## ADDENDUM NO. 1

**DATE:** March 13, 2024  
**FROM:** City of Grand Junction Purchasing Division  
**TO:** All Offerors  
**RE:** Re-Seeding of Flowline Property IFB-5408-24-DD

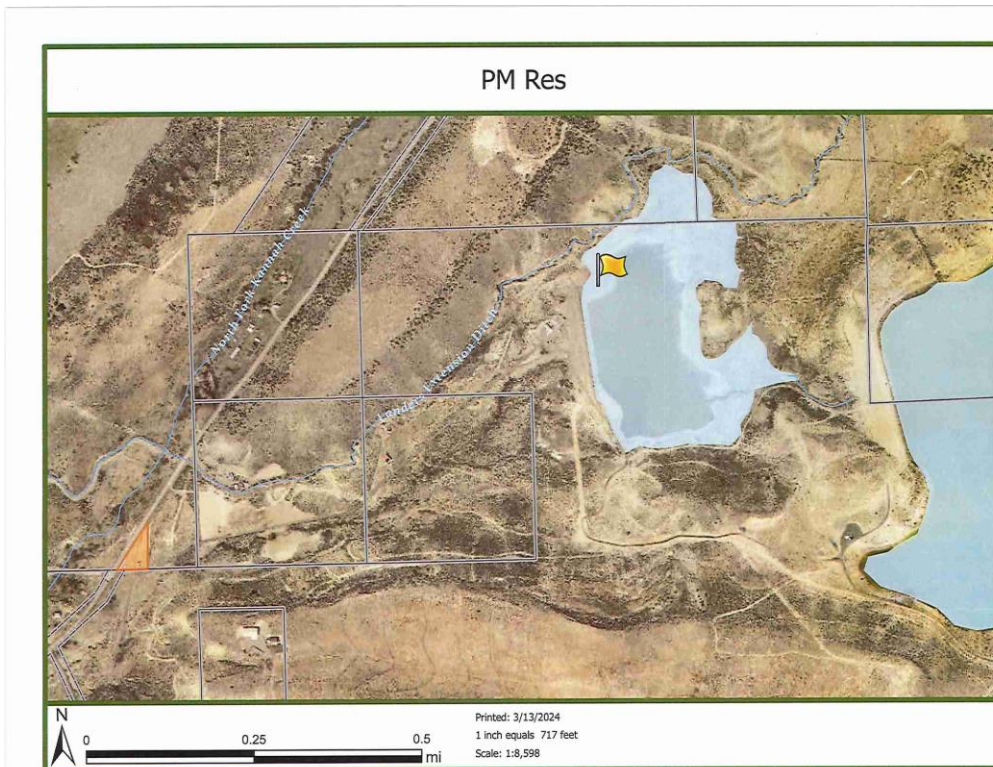
3. **Question:** Blue Sage Subdivision, will project include everything that is disturbed?

**Answer:** Where the scar turns northwest off Blue Sage Road (red star in the middle of the map), and seeding resumes, there was a staging area on the south side of the scar that is about 60' X 100' that should also be seeded. The City intends to keep this access road but wishes to have the disturbed area that is not part of the road to be seeded.
